## A10 Stoke Newington Gyratory

### Gyratory Removal (Changes Following Consultation Feedback)

Stage 1 Road Safety Audit

Ref: 3201.01/004/A10/TLRN/2019

**ST-PJ472C-RSM-FEA-04-DR-TE-01-0013**  
**P00.2**  
**DEPARTMENT**

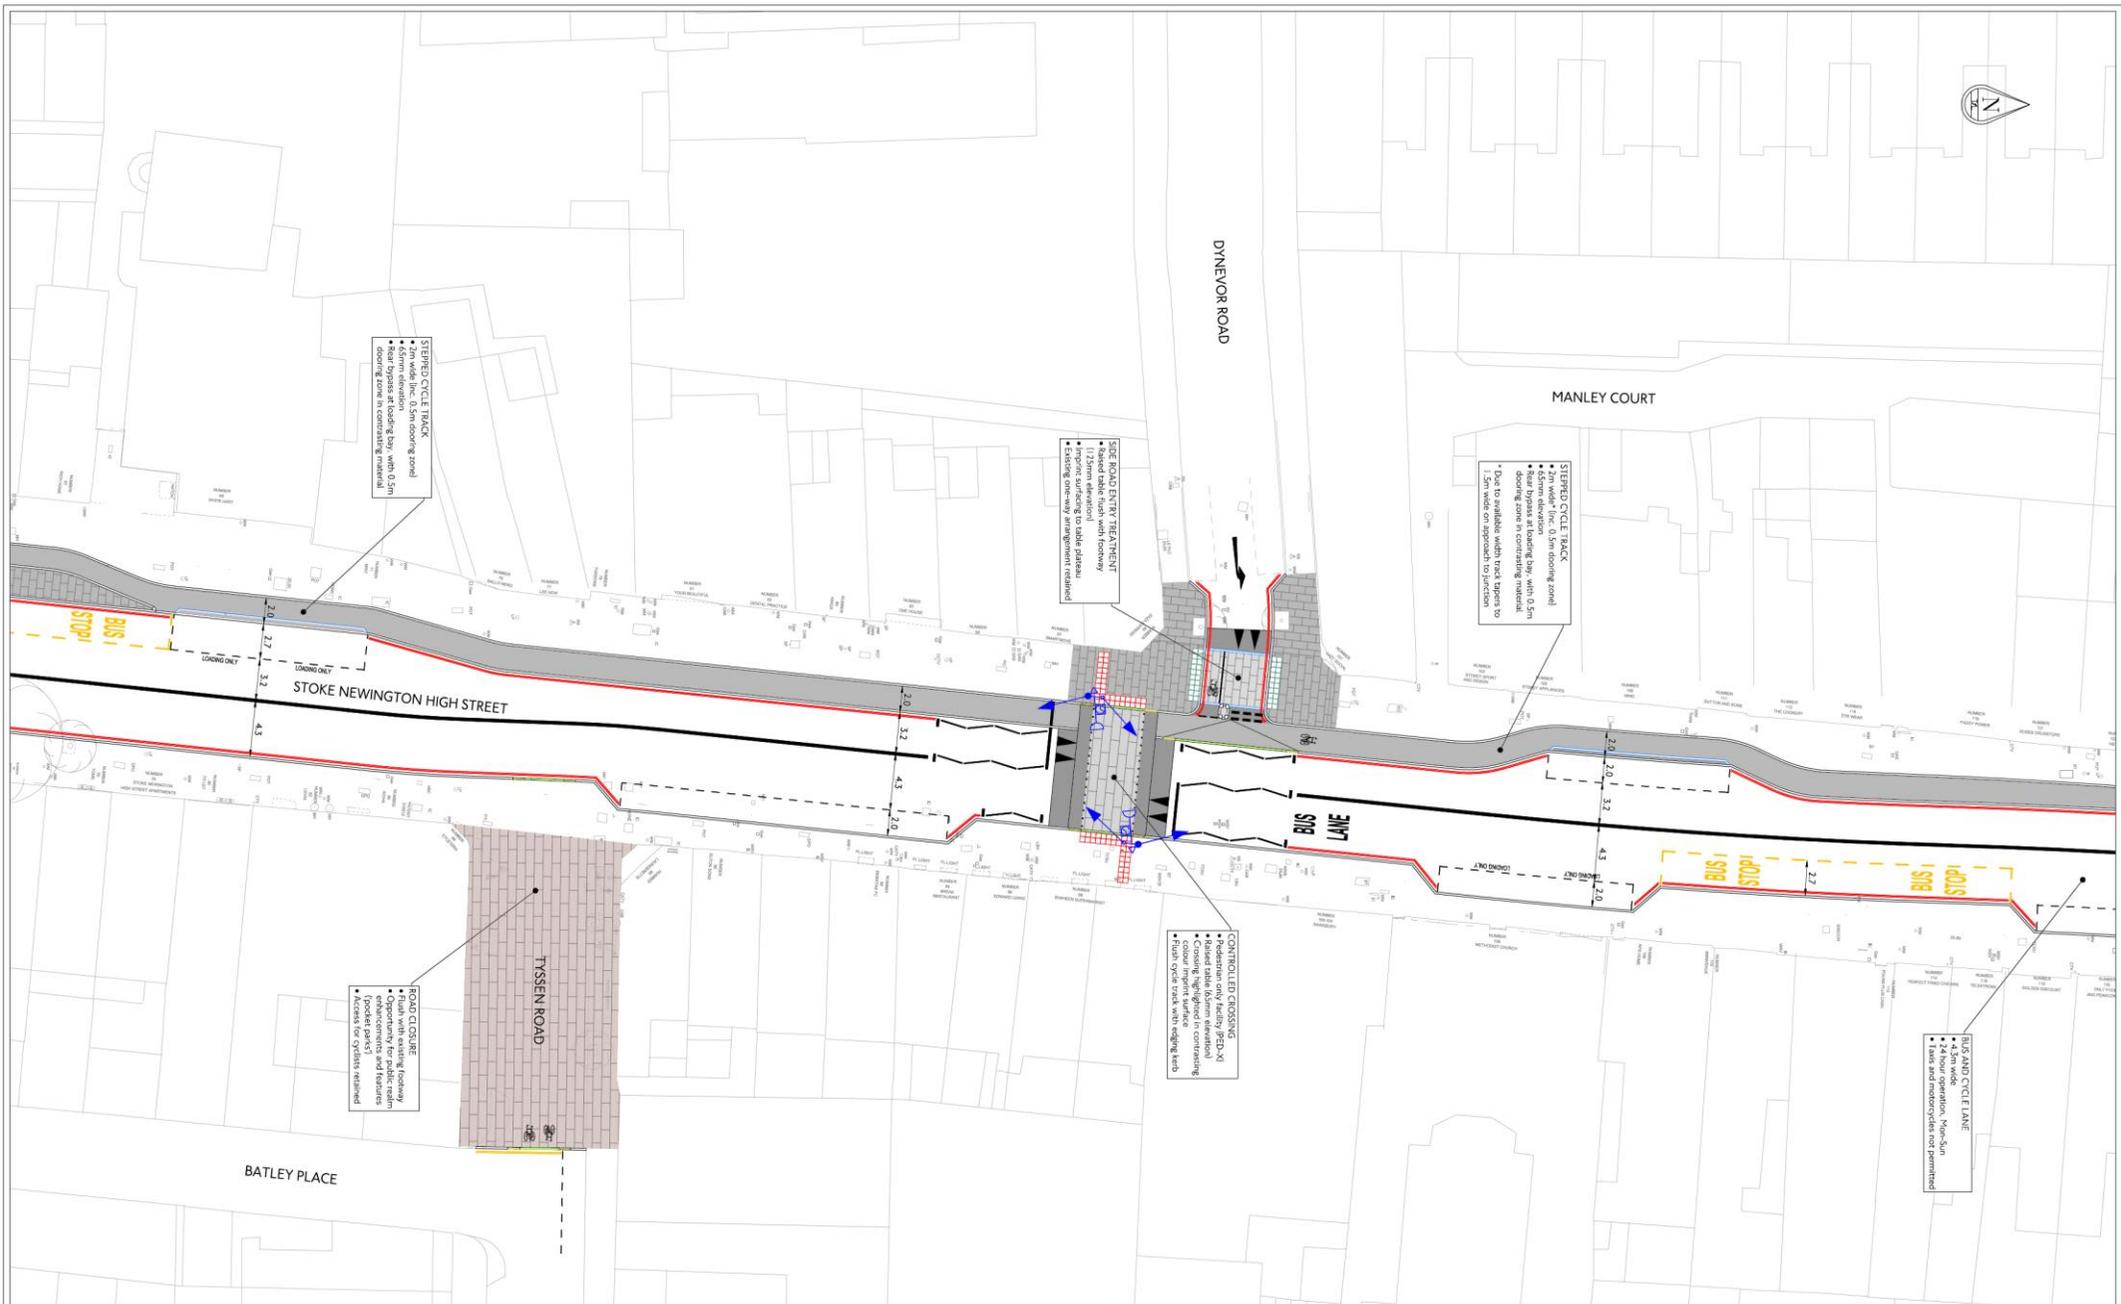
**3.3 RECTORY ROAD, BETWEEN NORTHWOLD ROAD AND STOKE NEWINGTON COMMON (SHEETS 0009, 0010 & 0013) – OVERRUN AREAS USING IMPRINT SURFACING ADJACENT TO THE KERBS REPLACE THE PREVIOUSLY PROPOSED FLUSH LEVEL CENTRAL MEDIAN STRIP. CYCLISTS WILL STILL BE ENCOURAGED TO TAKE THE PRIMARY POSITION BY CYCLE LOGO MARKINGS POSITIONED CENTRALLY IN BOTH LANES.**

**Location:** C – Rectory Road, variable width imprint surface overrun strip adjacent to kerbs.

**Summary:** The width and layout of the imprint may give the impression that the area is a cycle lane. Cyclists may adopt a secondary riding position. There may not be suitable width for vehicles to safely pass a cyclist adopting a secondary position. This may result in shunt and / or side swipe type collisions.

A variable width imprint surface overrun strip adjacent to the kerb is proposed to visually narrow the carriageway width to 6.0m to encourage cyclist to adopt a primary riding position. The width and layout of the imprint may give the impression that the area is a cycle lane and therefore cyclists may not adopt the primary position as intended. The speed and volume of traffic may also discourage cyclists from adopting a primary position.

Should cyclist adopt a secondary riding position within the imprint area, there may not be suitable width for vehicles to safely pass a cyclist. A potential for shunt and / or side swipe type collisions between vehicles and cyclists may exist as a result.

It is recommended that any narrowing of the carriageway using an imprint type material does not give the impression that it can be / should be used by cyclists. It may be beneficial to provide physical measures to reduce the carriageway to the required width.

<b>Design Organisation Response</b>	<b>Accepted / Part Accepted / Rejected</b>
<p>The Imprint surfacing will have a colour and pattern that provides a significant contrast to the asphalt carriageway surfacing, therefore highlighting to both cyclists and motor vehicle drivers/riders that this is not a dedicated space for cyclists.</p> <p>Additionally, an alternative design is being considered. This comprises 3.2m wide opposing traffic lanes, with the western kerb built out to increase the footway width.</p>	
<b>Client Organisation Comments</b>	
<p>Part accepted – Imprint is not a dedicated cycle facility, but a low cost method to give the impression of carriageway narrowing. As such double red lines will be marked to the outside of the imprint to highlight main carriageway.</p>

SHEET NO: 0004 OF 0020  
 DRAWING NO: P00.2  
 PROJECT: ST-PJ472C-RSM-FEA-04-DR-TE-01-0004

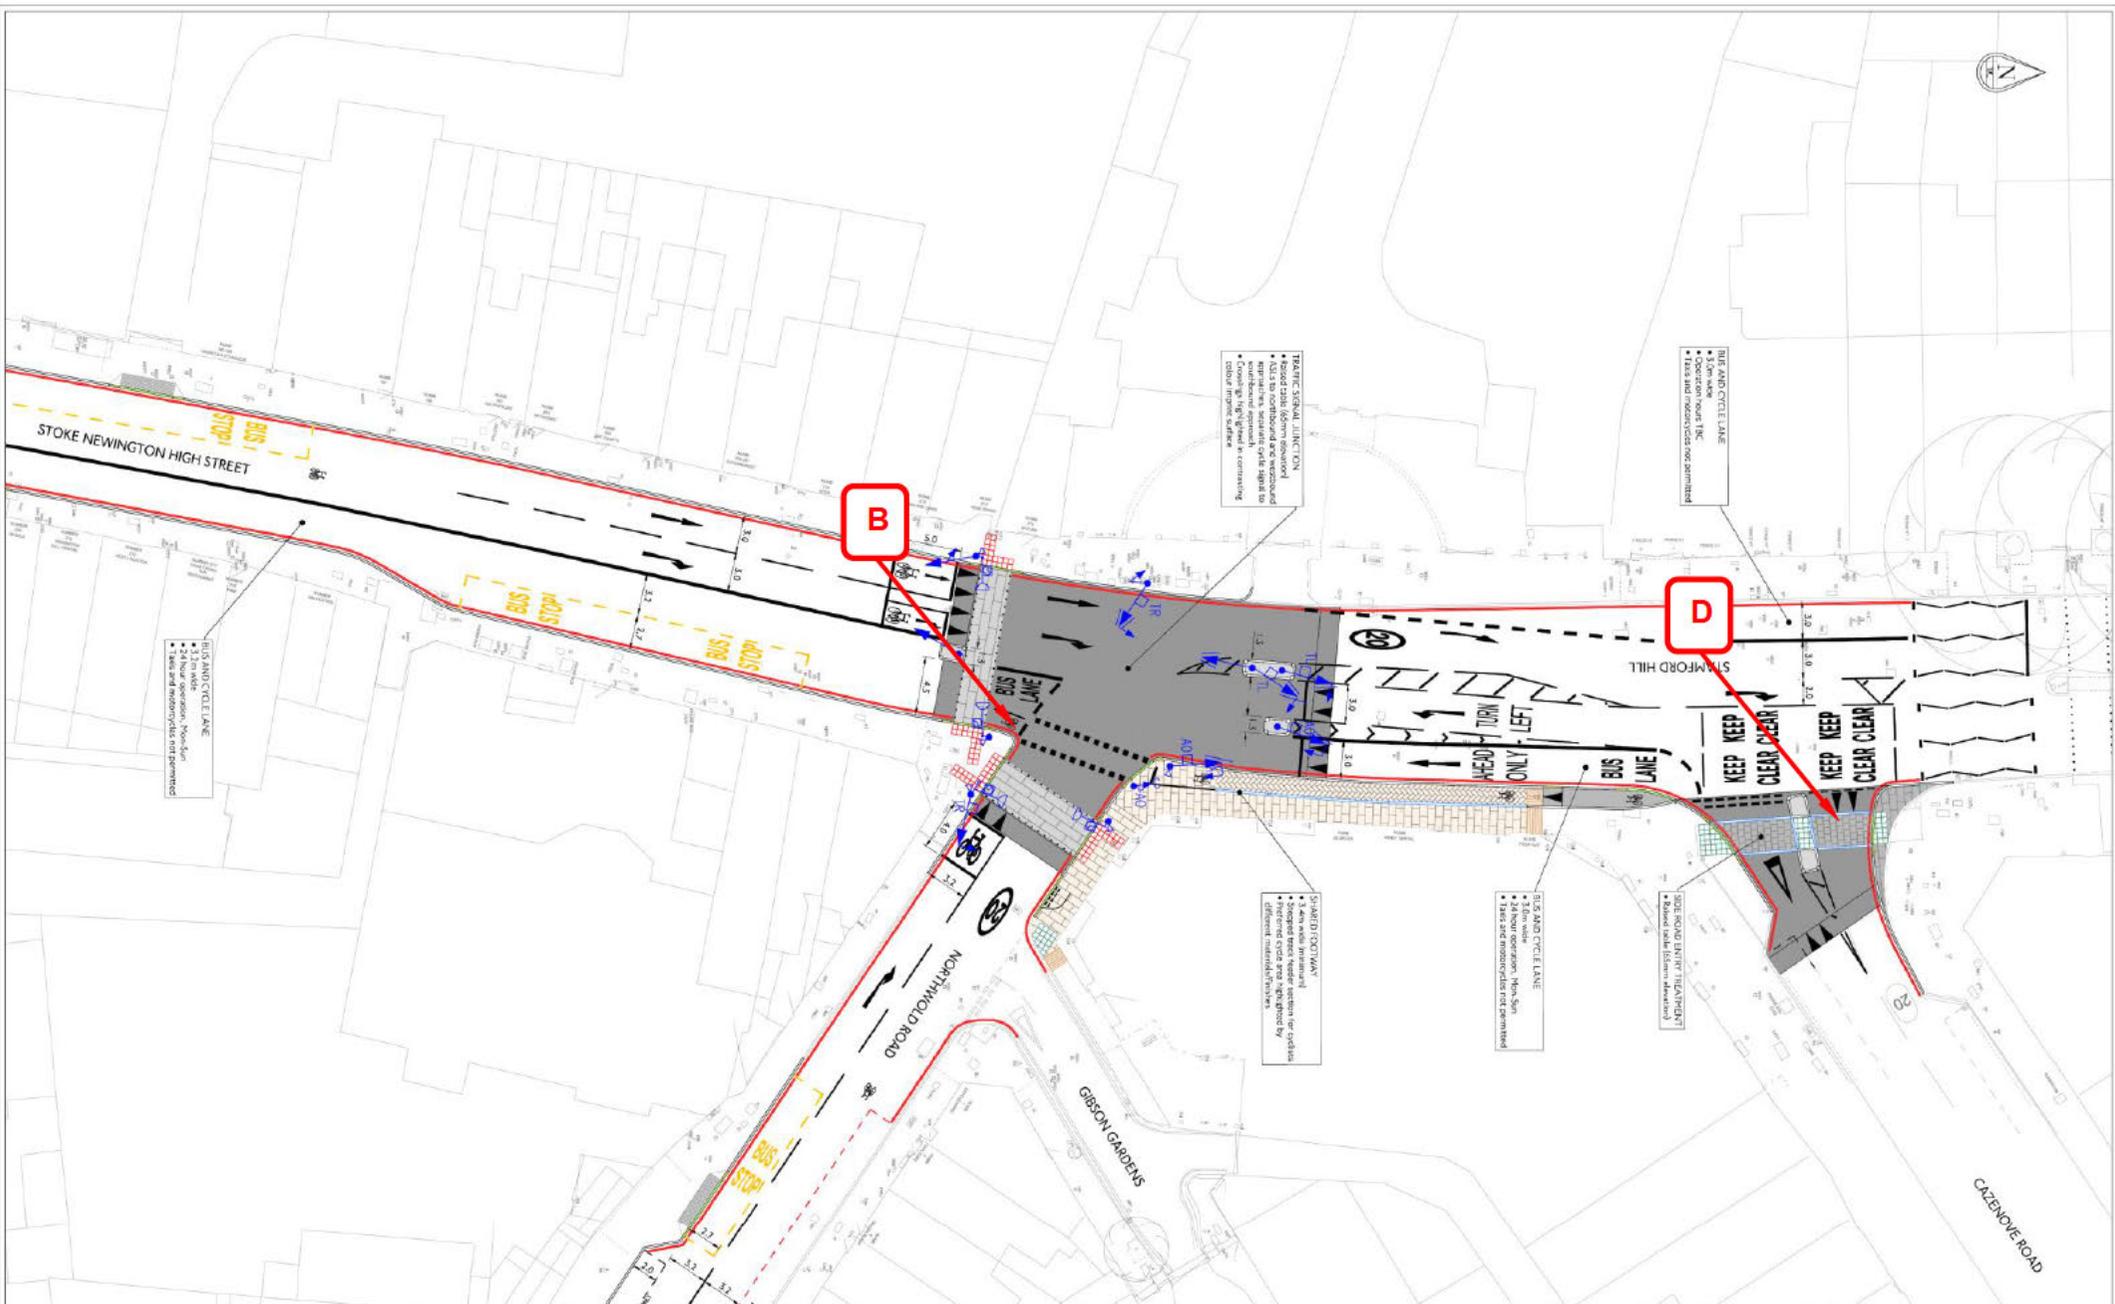
### 3.5 STOKE NEWINGTON HIGH STREET JUNCTIONS WITH VICTORIAN ROAD, VICTORIAN GROVE AND DYNEVOR ROAD (SHEETS 0002, 0003 & 0004) - FLUSH RAISED ENTRY TREATMENTS REPLACE THE PREVIOUSLY PROPOSED CONTINUOUS FOOTWAYS.

**Location:** E – Victorian Grove and Victorian Road junction with Stoke Newington High Street, stepped cycle track across the junctions.

**Summary:** Road users turning left into the side road may fail to appreciate the presence of cyclists on the stepped track. This may result in hook type conflicts.

The stepped track will be continued across the Victorian Grove and Victorian Road junctions. Cyclists on the stepped track will be remote from general traffic on the approach to the junction with little / no interaction beforehand. There is concern that road users turning left from Stoke Newington High Street may fail to appreciate the presence of cyclists on the stepped track, or understand that cyclists have priority over turning traffic. This could result in left-hook type collisions.

It is recommended that the junctions are made left out only to remove the potential conflict. If this cannot be achieved then it is recommended that further measures are provided to highlight the cycle track and the need to give way. This could include road markings and coloured surfacing.

Design Organisation Response	Accepted / Part Accepted / Rejected
<p>The design team has previously investigated restricting turning manoeuvres at both junctions. However it is not practical to make all roads joining onto the high street exit only. There is a Police Station located on Victoria Road which requires quick vehicular access to and from Stoke Newington High Street during emergency calls, making the conversion of Victoria Road to one-way out impractical. Furthermore, the borough do not support new one-way streets, meaning that the existing two-way operation has been retained for Victoria Grove.</p>	
<p>The cycle track is +65mm above the adjacent carriageway, with a ramp down at the side road to be flush with the carriageway. Both the cycle track and carriageway are to be surfaced in standard black asphalt. The cycle track effectively operates as a mandatory cycle lane, which includes diag. 1057 cycle logo markings and diag. 1004 lane markings across the junction with the side road as specified in TSRGD 2016. Both of these road markings are proposed in these locations.</p>

Client Organisation Comments
<p>Rejected – there will be no right turn for general traffic from side roads as the southbound lane on Stoke Newington High St will be a bus lane for buses and cycles only. Only emergency vehicles may use this as access.</p>

Surface Transport  
 Road Space Management  
 Outcomes Design Engineering  
 53 | ST-PJ472C-RSM-FEA-04-DR-TE-01-0008  
 P00.2  
 DRAFT

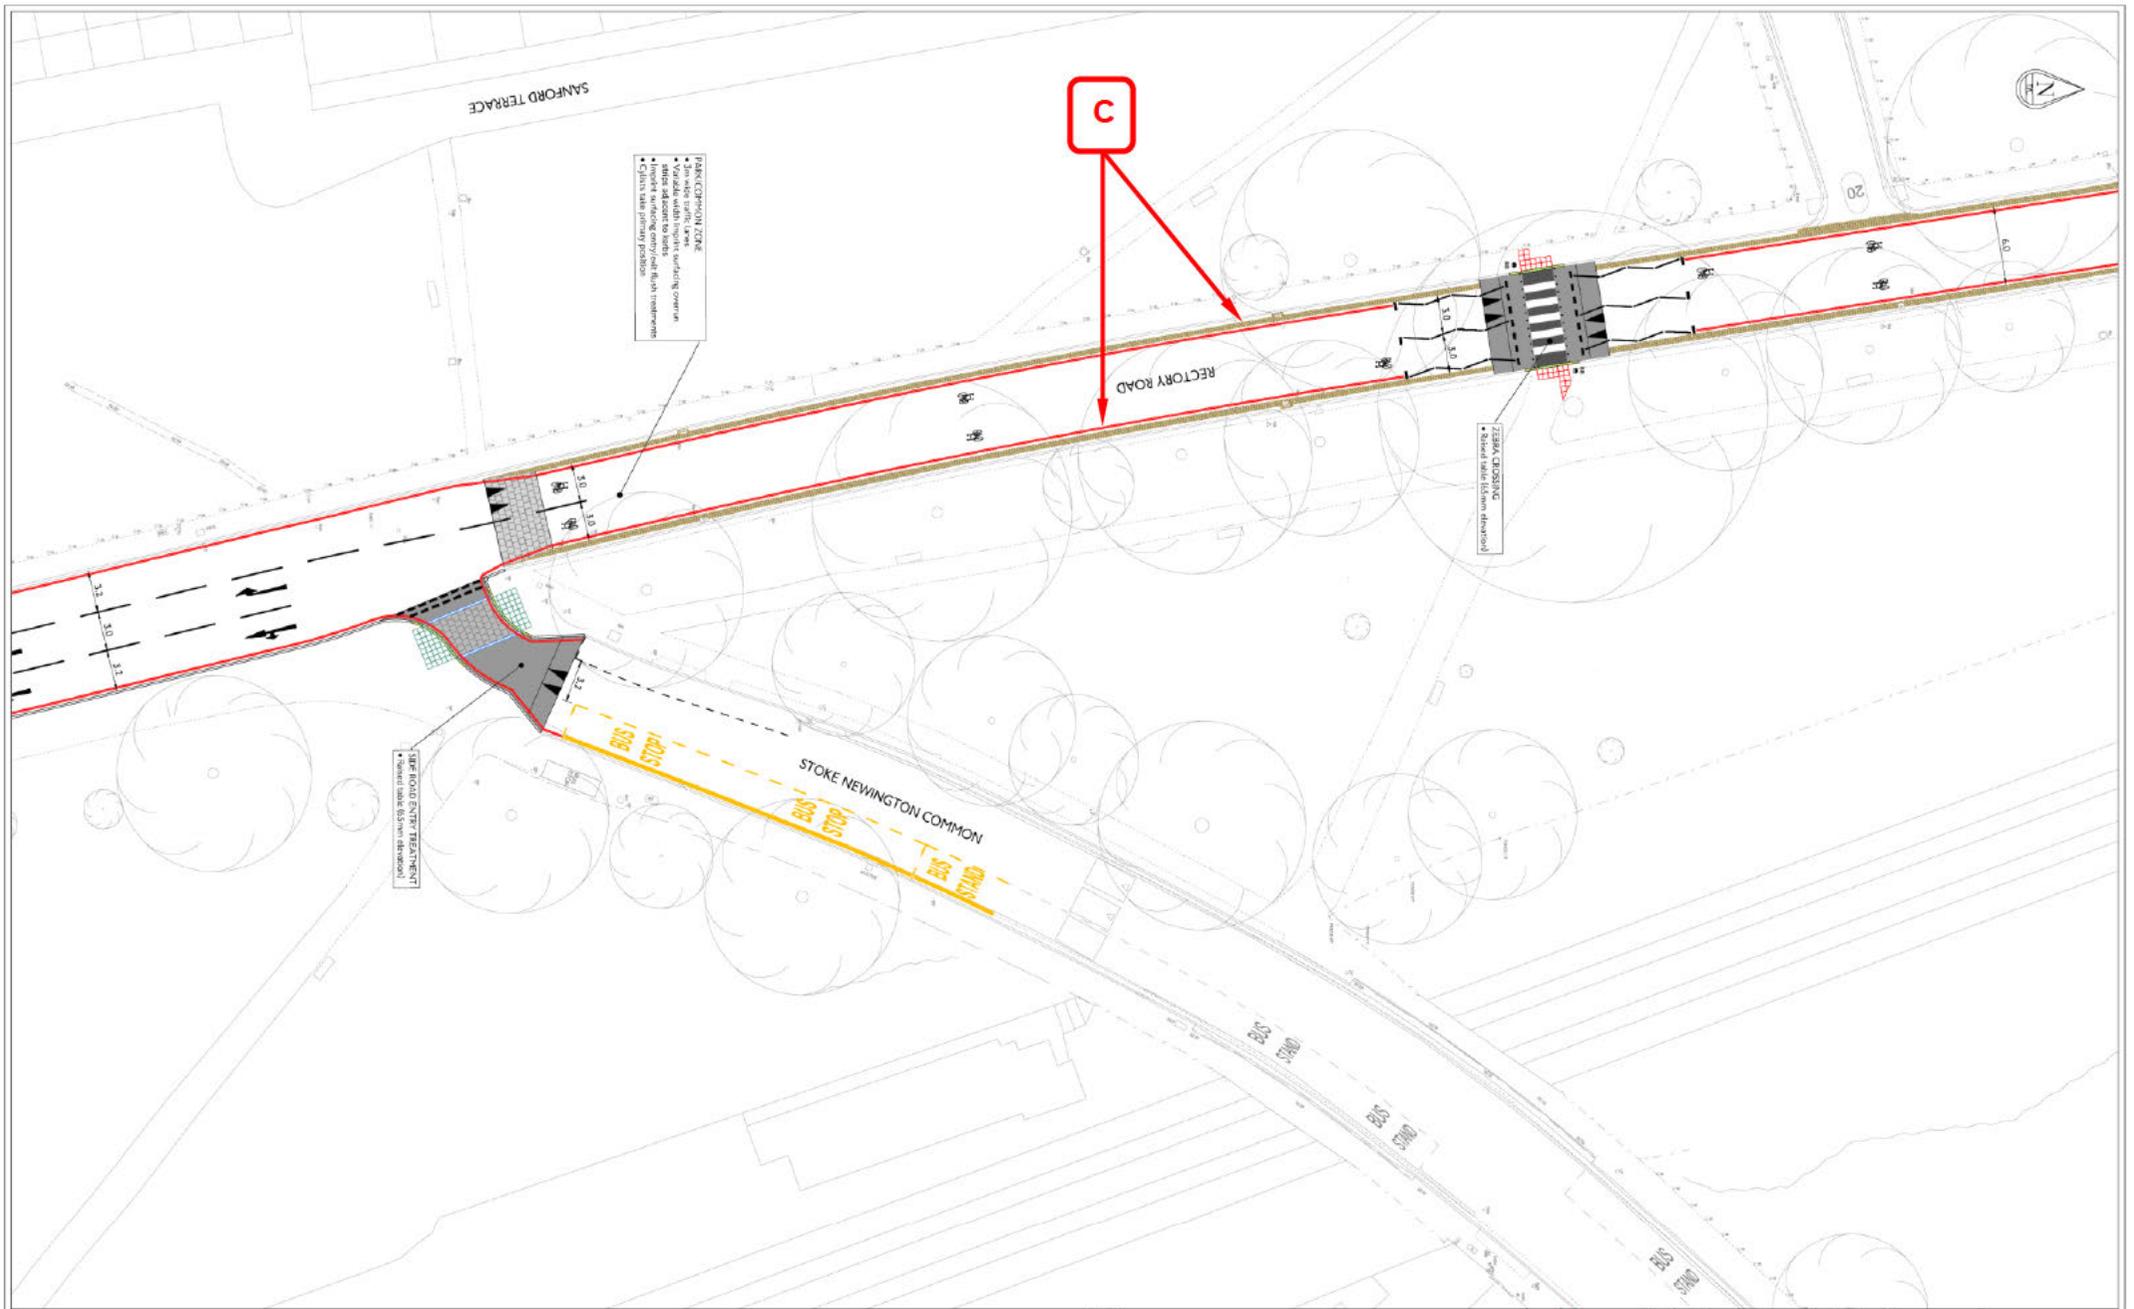
**3.2 STAMFORD HILL JUNCTION WITH NORTHWOLD ROAD (SHEET 0008) – SOUTHBOUND CYCLISTS WILL NOW BE SEGREGATED FROM TRAFFIC WHEN USING THE STEPPED TRACK/SHARED FOOTWAY. CYCLE SIGNALS ARE ALSO PROVIDED FOR CYCLISTS PROCEEDING DOWN STOKE NEWINGTON HIGH STREET.**

**Location:** B – Stamford Hill southbound towards Stoke Newington High Street, stepped track.

**Summary:** Proposed method of control whereby the southbound ahead only bus lane is given a green signal at the same time as the southbound stepped track re-joins the carriageway may result in side swipe type collisions on the exit from the junction.

Stage 1 of the proposed Method of Control shows the southbound ahead only bus lane given a green signal at the same time as the southbound stepped track that re-joins the carriageway. The alignment of the bus lane and the cycle track on the southern side of the junction may result in buses squeezing cyclists as they enter Stoke Newington High Street (it is appreciated that the stop line of the stepped track is located further south than that of the bus lane, however southbound cyclists approaching the stop line towards the end of the phase may be at risk). Buses will also be seeking to move to the nearside to access the bus stop on the exit from the junction, further compounding the potential issue. This may result in side swipe type collisions between cyclists and buses.

It is recommended that the signal method of control is adjusted so that southbound cyclists do not run at the same time as southbound buses. This could be achieved by providing a separate stage for cyclists.

**3.4 STAMFORD HILL JUNCTION WITH CAZENOVE ROAD (SHEET 0008) - INTRODUCE A NEW RAISED ENTRY TREATMENT TO REDUCE SPEEDS FOR BOTH VEHICLES TURNING INTO CAZENOVE ROAD, AND ON THE APPROACH TO THE JUNCTION FROM THE EAST. REDUCE THE OVERALL CROSSING DISTANCE BY BUILDING OUT THE NORTHERN FOOTWAY.**

**Location:** D – Stamford Hill left turn into Cazenove Road.

**Summary:** The proposed footway buildout may impact on the swept path of vehicles turning left into Cazenove Road. Vehicles may overrun the new kerb buildout. This could result in collisions with pedestrians on the footway.

It is proposed to build out the northern footway of Cazenove Road to reduce the crossing distance for pedestrians. To achieve this, the existing junction corner radius has been reduced. Vehicles turning left into Cazenove Road may have difficulty completing their manoeuvre within the confines of the carriageway and may overrun the new kerb buildout. This could result in collisions with pedestrians on the footway.

It is recommended that swept path analysis is undertaken to demonstrate that all expected vehicle types can complete their manoeuvre without overrunning the footway buildout. It may be necessary to adjust the proposed kerb line and / or provide a physical feature such as a bollard.

Design Organisation Response	Accepted / Part Accepted / Rejected
<p>The kerb alignment on the northeast footway will deflect buses into the marked bus lane entry, which has a width of 3m, with the overall width between the central traffic island and eastern footway being 4.5m. Thus is the minimum recommended width that will accommodate a bus and cycle together. The inclusion of ‘elephant footprint’ markings to denote the cycle crossing lane also highlights the presence of cyclists and also directs buses away from the cycle lane. While we do not have sufficient space to provide a cycle facility on the southbound exit eastern footway, the addition of coloured surfacing to highlight the cycle exit lane is to be considered.</p> <p>Due to capacity constraints and the requirement to have a neutral or positive effect on bus journey times, a separate cycle stage is not feasible.</p> <p>The stop on the High Street southbound exit will serve 3 No. bus routes (76, 149, 243). We do not have sufficient space to provide an on-footway facility, such as a bus stop bypass, but will provide additional diag. 1057 cycle logo markings at the corners of the bus stop cage marking. This will provide awareness to bus drivers that cyclists are likely to overtake stationary buses. This is the standard design for this situation.</p>

Client Organisation Comments	
Part-accepted agree with designer

<b>Design Organisation Response</b>	<b>Accepted / Part Accepted / Rejected</b>
<p>The southbound carriageway features a nearside bus lane, so all larger vehicles such as refuse and goods vehicles will turn left into Cazenove Road from the offside lane. This allows a much tighter radius on the corner of the northeast footway and the proposed buildout to be implemented.</p> <p>A swept path analysis of the new layout has been carried out for all movements on the junction.</p>	
<b>Client Organisation Comments</b>	
Part-accepted agree with designer
